URBAN DESIGN COMMISSION APPLICATION

RE: **CMFG Life**
5810, 5910, and 5710 Mineral Point Road
Major Alteration to an Approved Comprehensive Design Review (from February 9, 2022)

Attached please find revised design materials for consideration of a Major Alteration to the Approved Comprehensive Design Review for **CMFG Life**, located at 5810, 5910, and 5710 Mineral Point Road.

2023 Site Plan

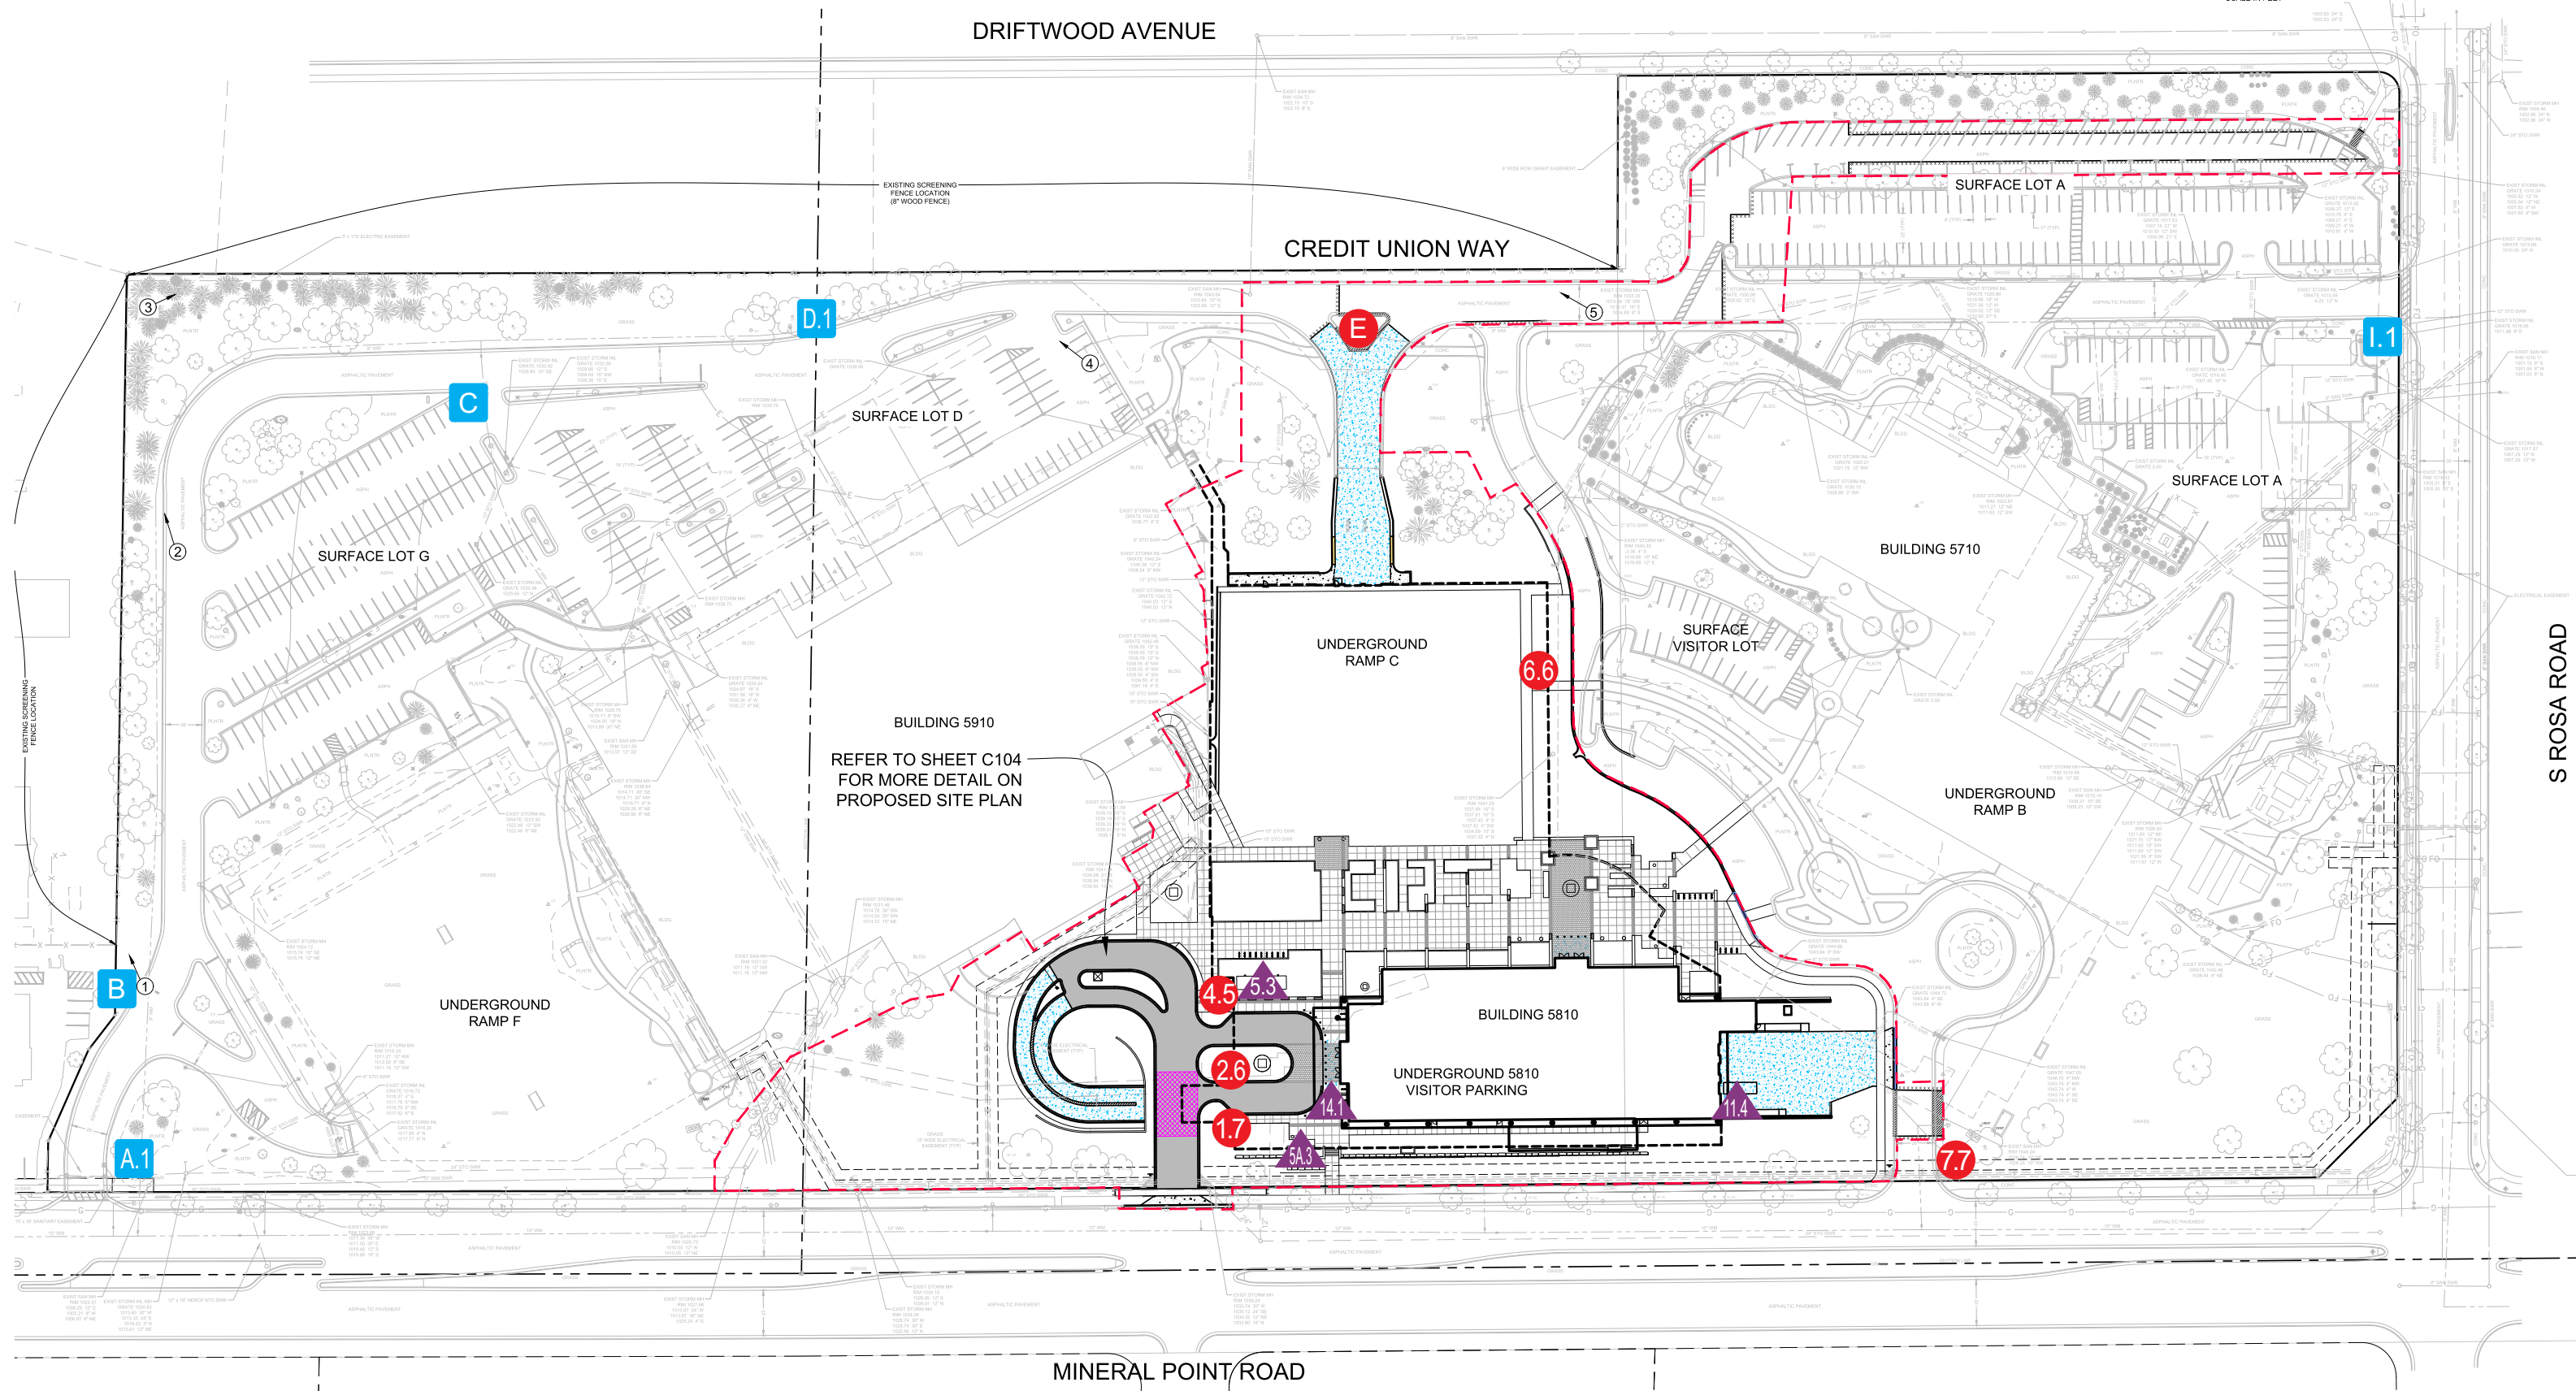
- Four wayfinding locations have been removed from the originally approved CDR.
6. The original and proposed site plans are included in this package.

5.3 CUNA Mutual Group - Internally Illuminated Channel Letters - Plinth

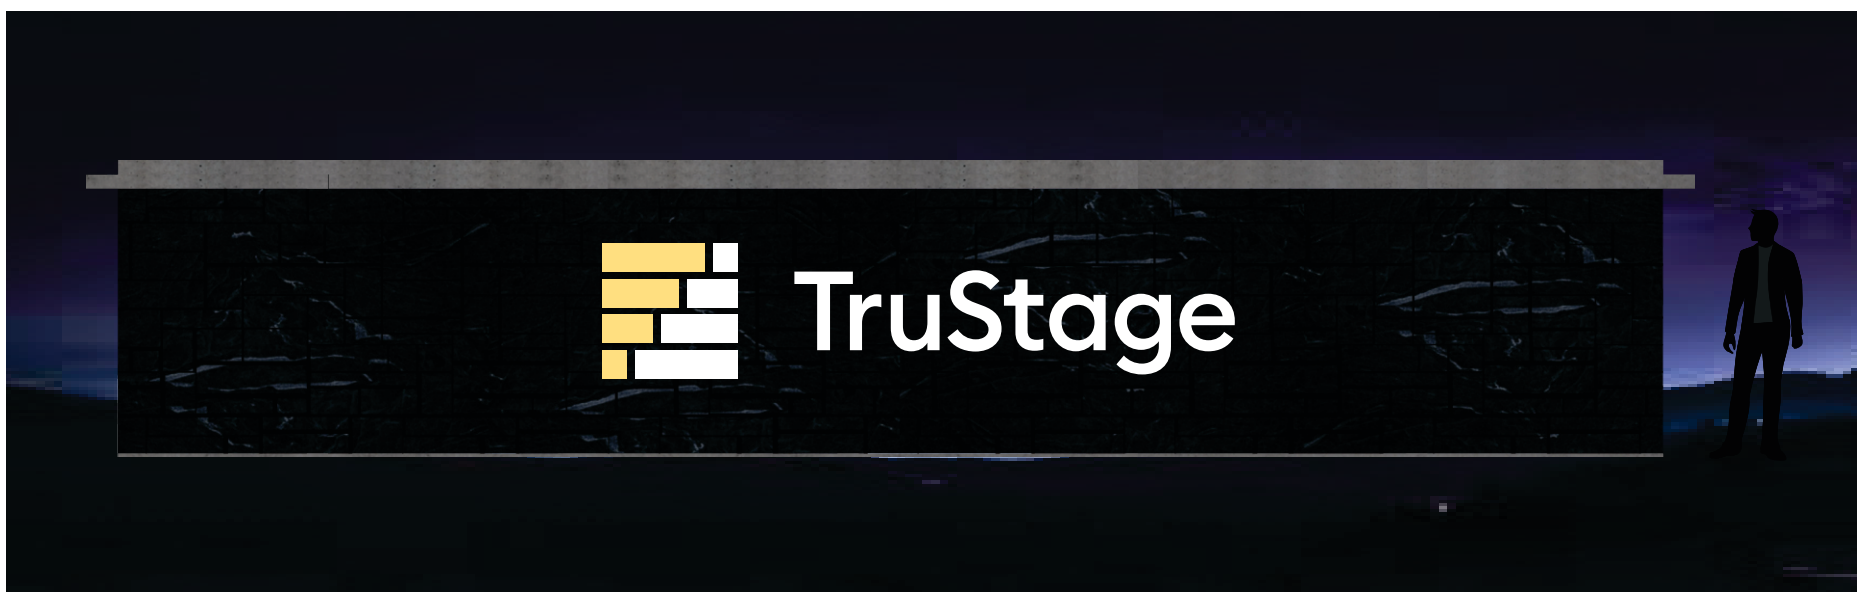
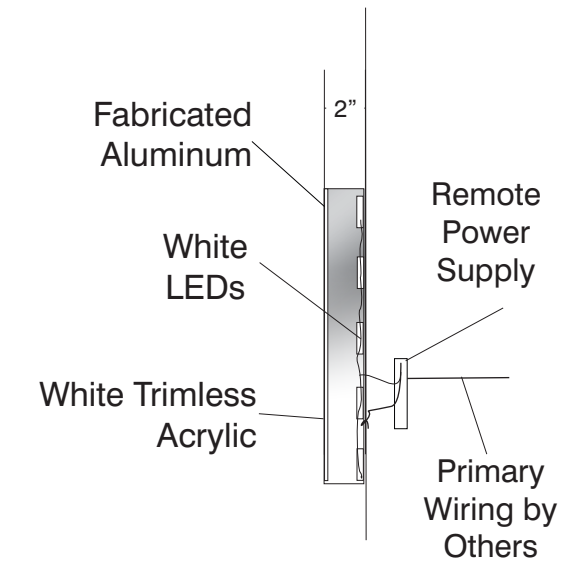
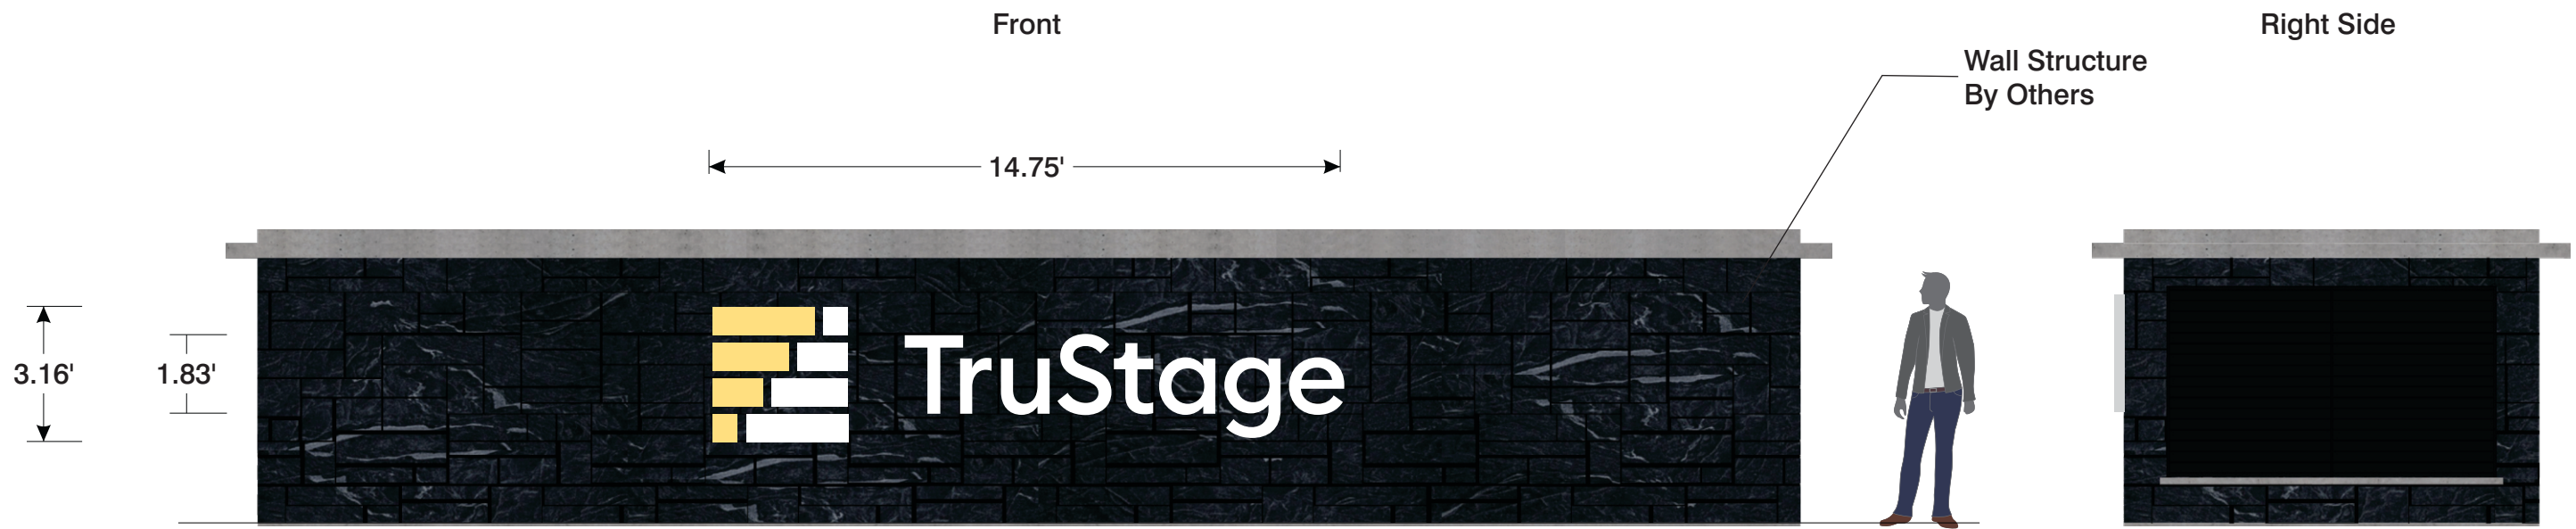
- To be consistent with all of the signage using individual, illuminated letters, we request the use of internal illumination for the letters on the plinth wall (Design 5A.3), the ramp wall (Design 5.3) , and the east (Design 11.4) and west (Design 14.1) rail sections of the building elevations.

- Up to 32.61 sf2 (copy area only) individual illuminated letters
- **Internally illuminated letters and logo to match proposed wall signs (proposed at 32.61 sf2)**
- Illuminated using white LED
- Plinth wall area of 222.12 sf2 (**Net sign area is approximately 15% of total freestanding wall**)

| SIGN TYPE | CODE REFERENCE | SIGN DETAIL | Approved by UDC ON 2-9-22 | Request for Approval |
|---|--|--|--|--|
| 5.3 Plinth Wall | FREESTANDING CAMPUS IDENTIFICATION SIGN | Up to 32.61 sf2 net copy on 222.12 sf2 freestanding wall. Sign will consist of individual, back-lit illuminated letters. | APPROVAL to allow for: 1. 50 net sf2, back-lit illuminated letters as included in CDR submittal. | Request approval for: 1. Internally illuminated letters/logo 2. NTE 32.61 net sf2. |

5A.3 CUNA Mutual Group - Internally Illuminated, Back Lit Letters - Ramp

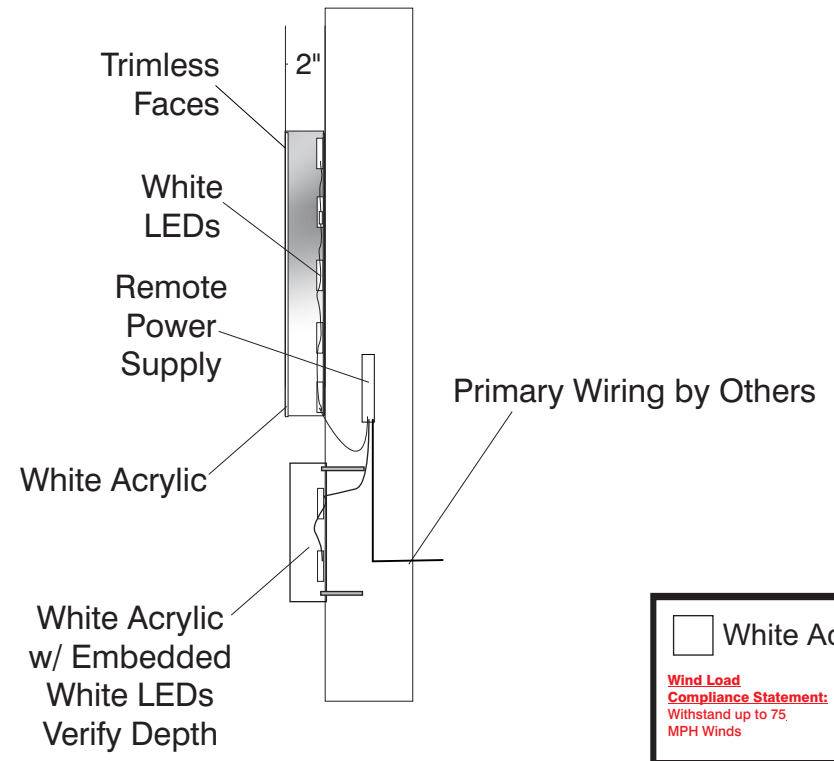
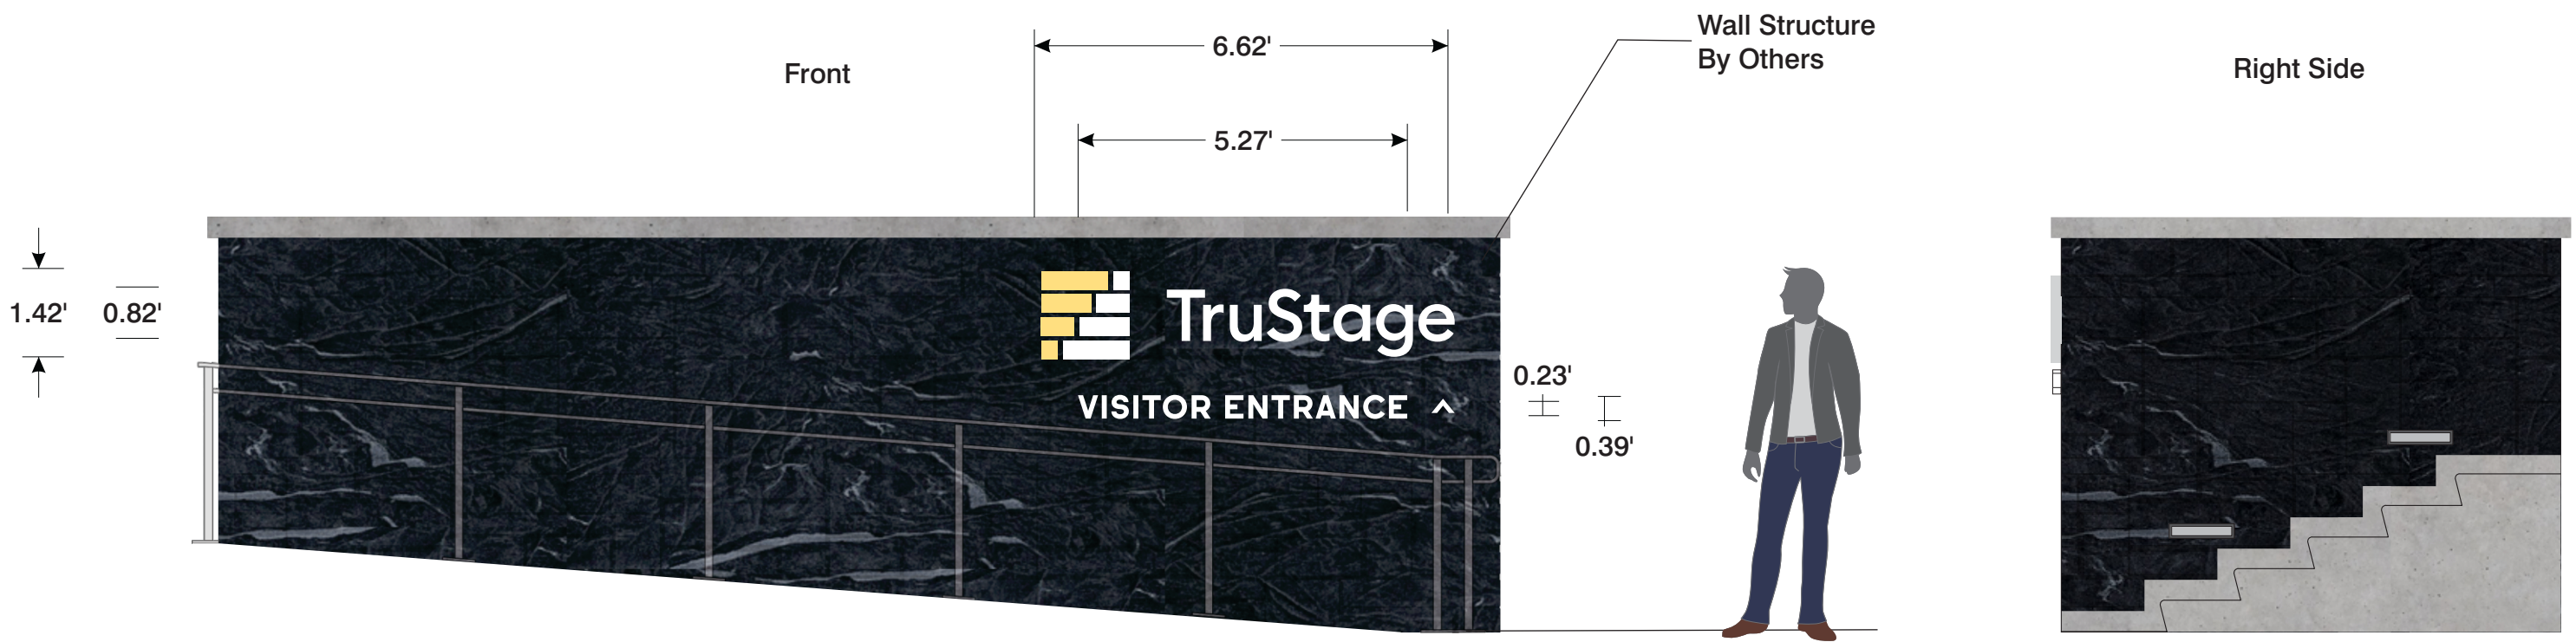
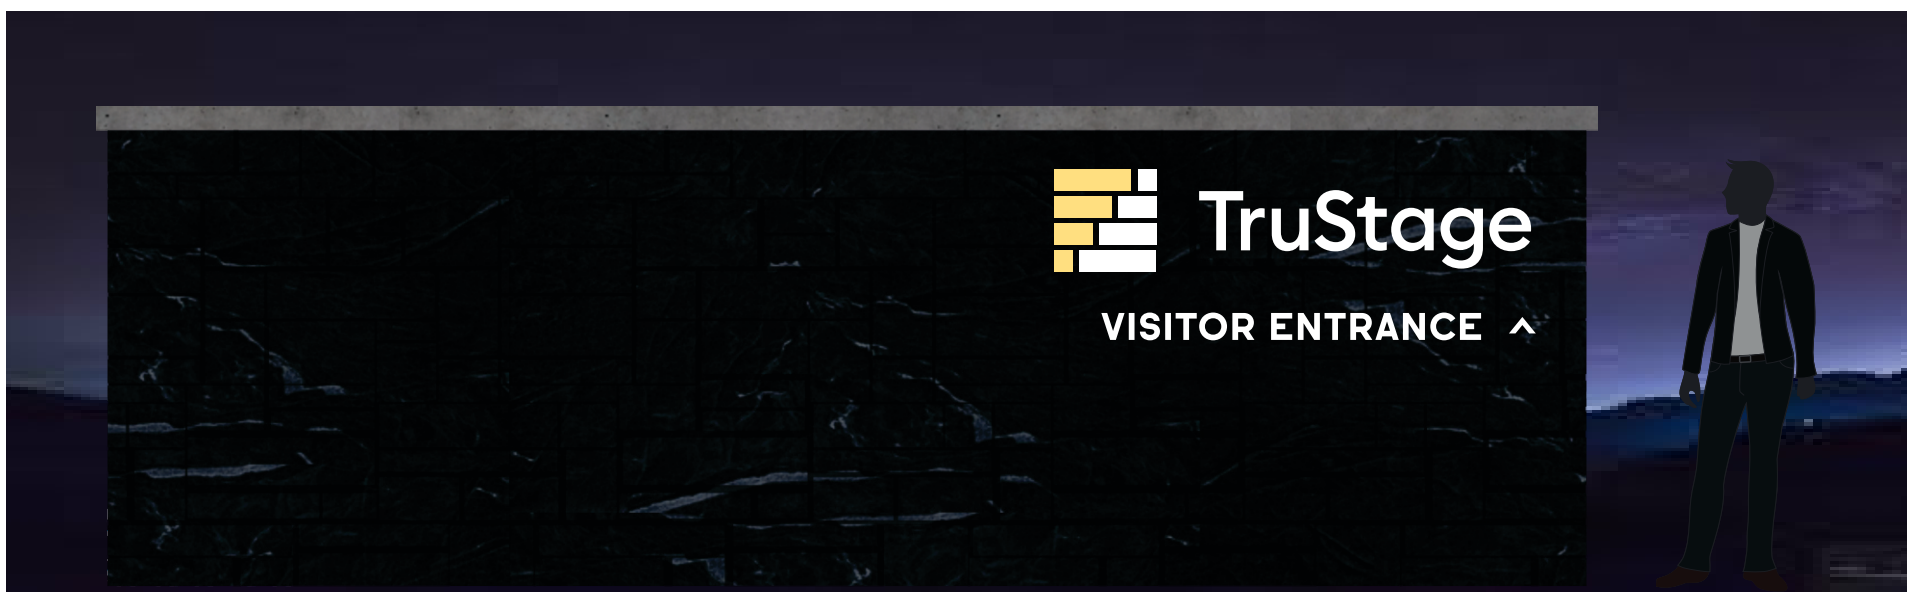
- Up to 13.61 sf2 (copy area only) internally illuminated, individual letters
- **Internally illuminated letters and logo to match proposed wall signs (proposed at 13.61 sf2)**
- Illuminated using white LED
- Ramp wall area of 100.86 sf2 (**Net sign area is approximately 13.4% of total freestanding wall**)

| SIGN TYPE | CODE REFERENCE | SIGN DETAIL | Approved by UDC ON 2-9-22 | Request for Approval |
|---|--|--|--|--|
| 5A.3 Ramp Wall | 31.03 PARKING LOT DIRECTION SIGN | Up to 13.61 sf2, net copy on 100.86 sf2 freestanding wall. Sign will consist of individual, back-lit illuminated letters. | APPROVAL to allow for: 1. 20 net sf2, back lit- illuminated letters as included in CDR submittal. | Request approval for: 1. Internally illuminated letters/logo 2. NTE 13.61 sf2. |
